AD73360 Rev. 1

Errata Document

A. This document details the limitations of the cascading option of the AD73360 due to a bug in the current silicon.

Figure 2. Cascade Timing for a Three-Device Cascade

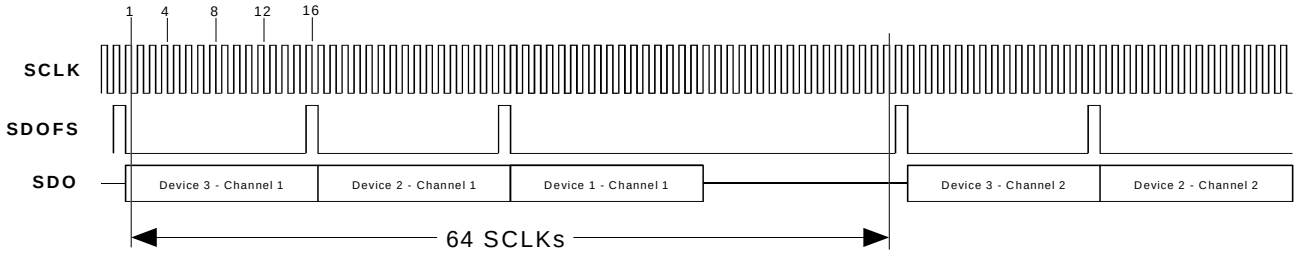
For cascades of more than two devices the AD73360 will leave too many SCLKs between transmitting channel information. This increases the time it takes to transmit the ADC data and since a DSP or microcontroller must read data from all the ADCs in the cascade in one sample period the number of devices which can be cascaded will be limited. Figure 2 shows the effect the additional SCLKs have on a cascade of three devices.

For a cascade of a given length, the SCLK rate and Sample Period will determine if the cascade can be used successfully. A low sample rate will allow more time for the ADC data to be read. Similarly a high SCLK rate will transmit the data in a shorter time. Since both the SCLK rate and Sample Rate are derived from the same DMCLK the number of combinations is limited. As most applications will require a predetermined sample rate, the SCLK speed will be the limitating factor in the cascade length that can be used. Table I shows the maximum cascade length for a given SCLK and Sample Rate. The table assumes that a MCLK of 16.384MHz is used.
